SEWAGE DISPOSAL SYSTEM

MARYLAND STATE DEPARTMENT OF HEALTH

A REPAIR

PROPERTY OWNER John C. Pickett4851 Wharff LaneADDRESS Ellicott City, Maryland

Property of
MILTON AGETSTEIN ET UX
1st Election District
Howard County, Maryland
April 12, 1968
Scale 1" = 50'

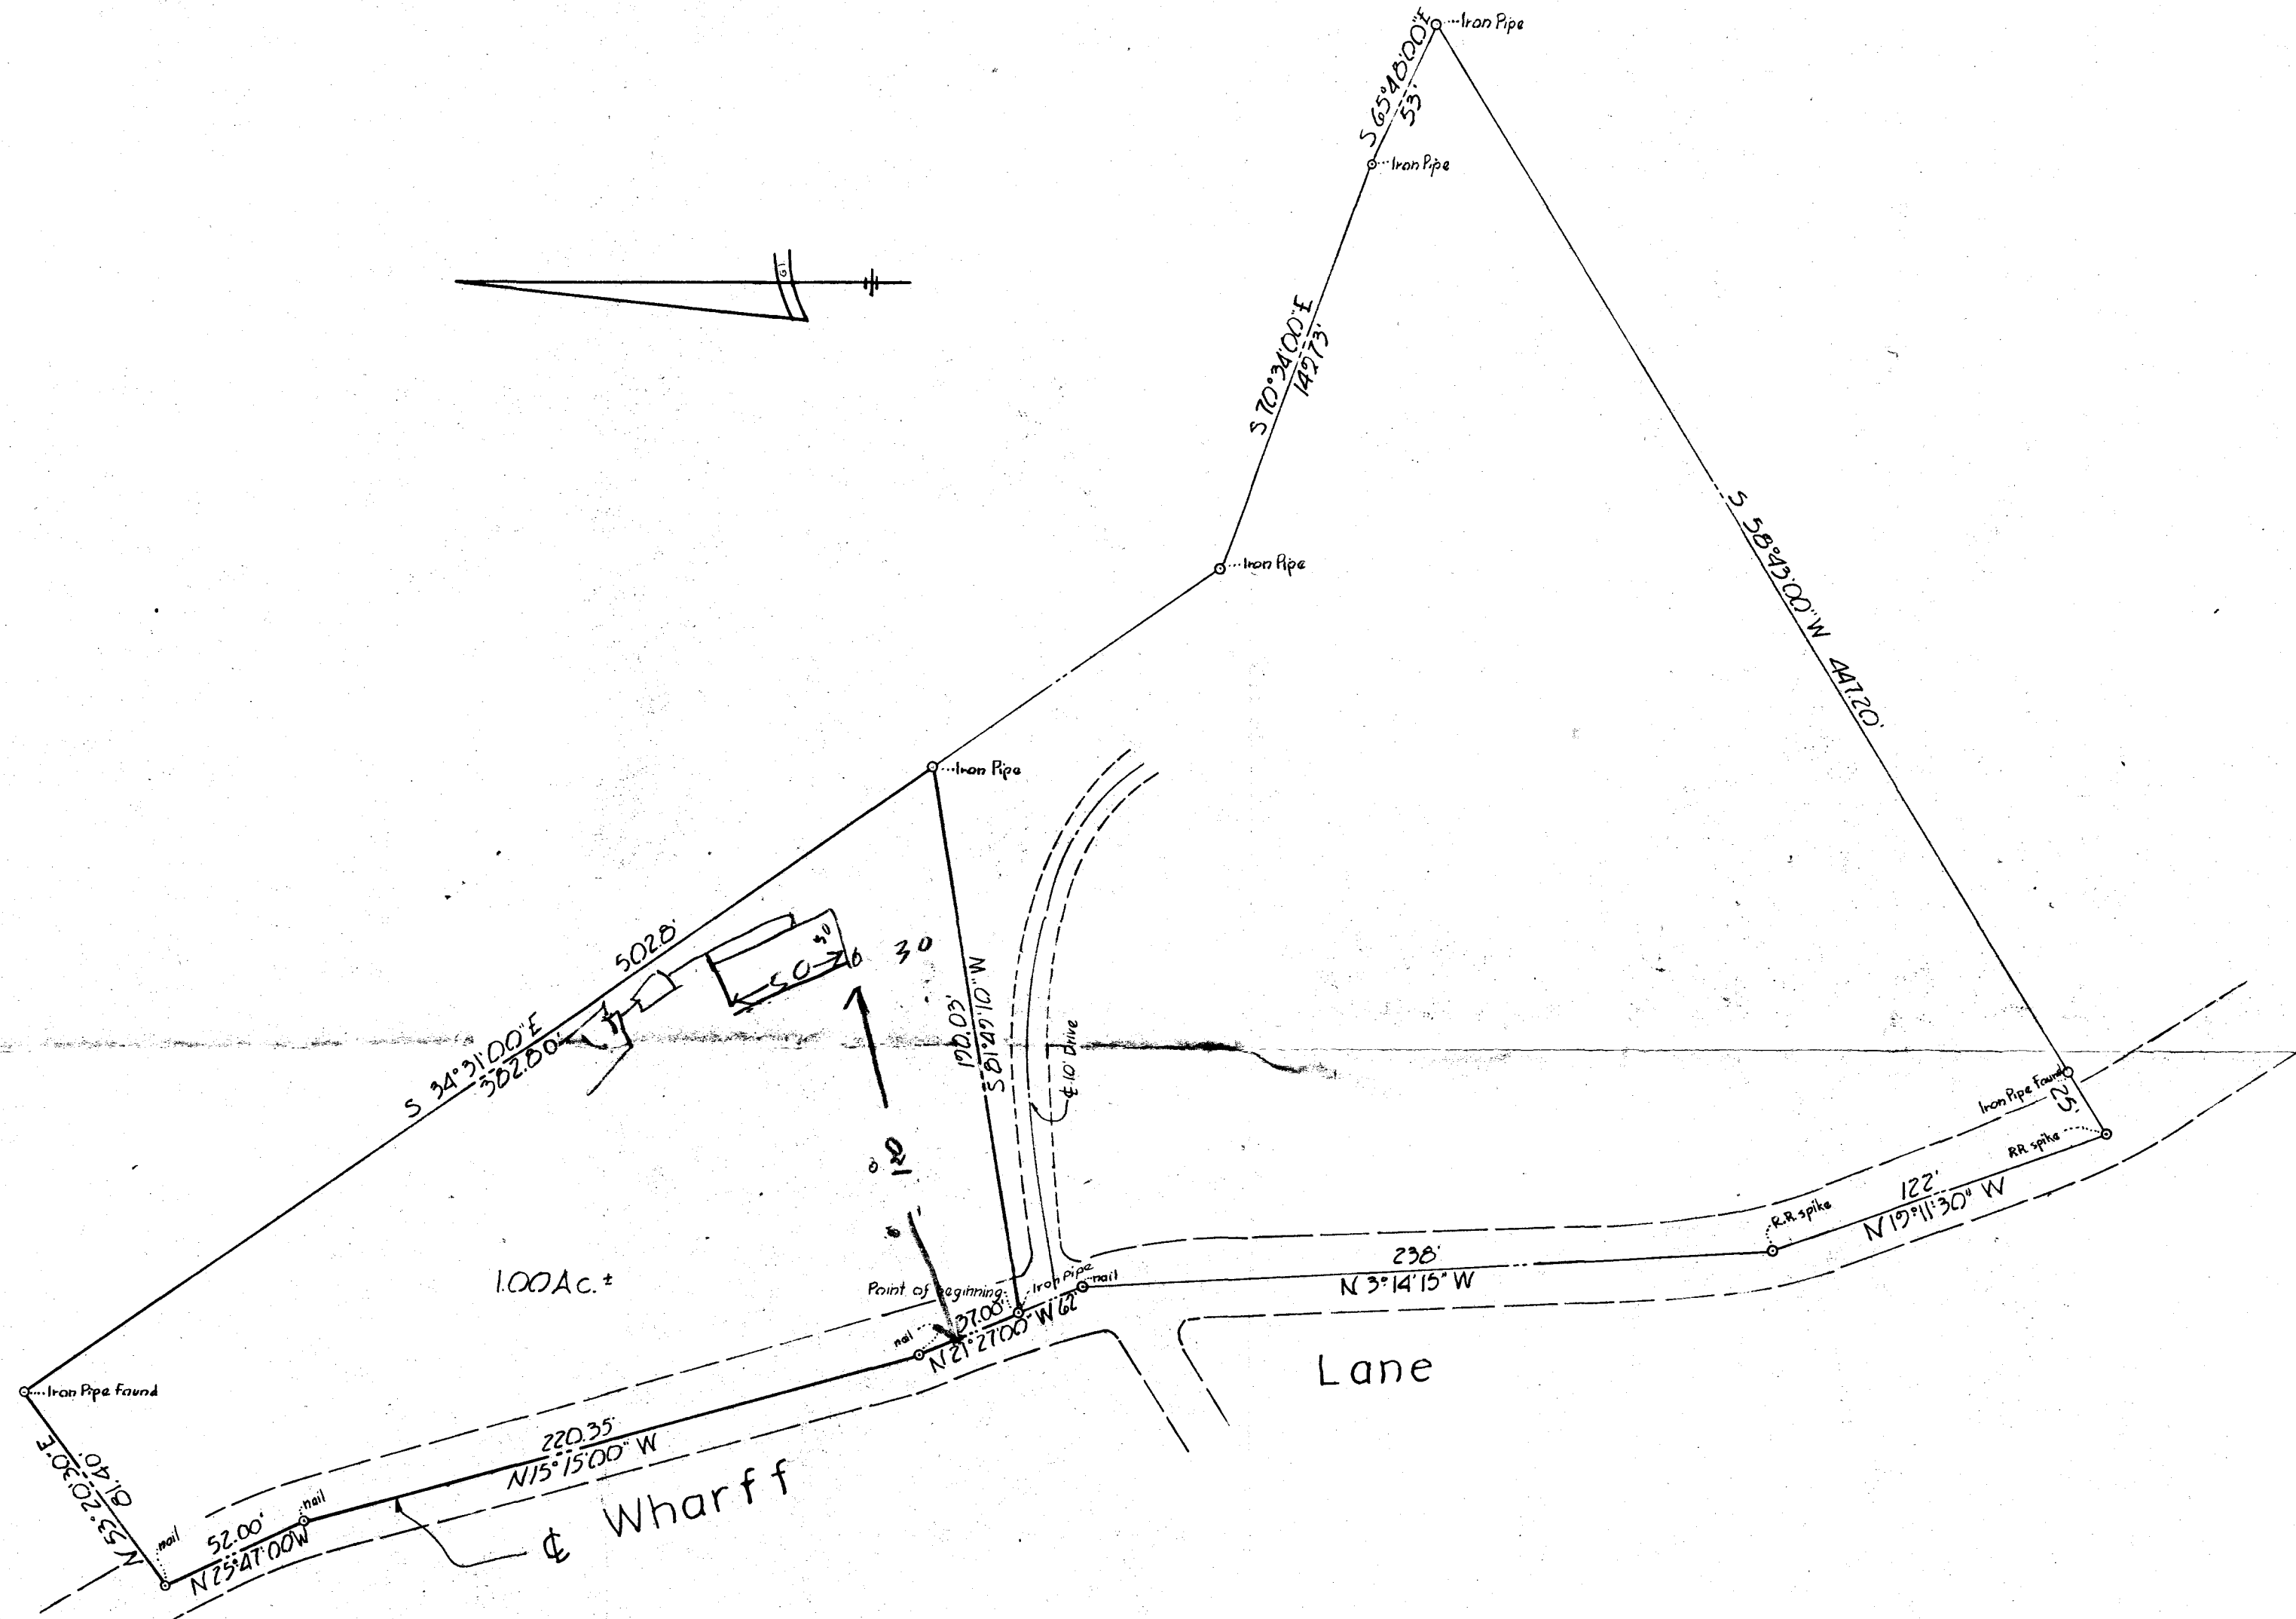
OTHER Tile field to be 300 sq. ft. bottom area. Place drain field in area
between 20 ft. and 80 ft. from front lot line and between 110 and 170 ft. from
right side line, as seen from facing lot from Wharff Lane. Max. depth 3½ ft.
from original grade.

*Septic to be 750 gall
Tile field to be ~~300~~ 300 ft between area, etc.
Place Drain field in area between 20 ft and 80 ft
from front lot line and between 110 and 170 from Right
side line. as seen from facing lot from Wharff Lane.*
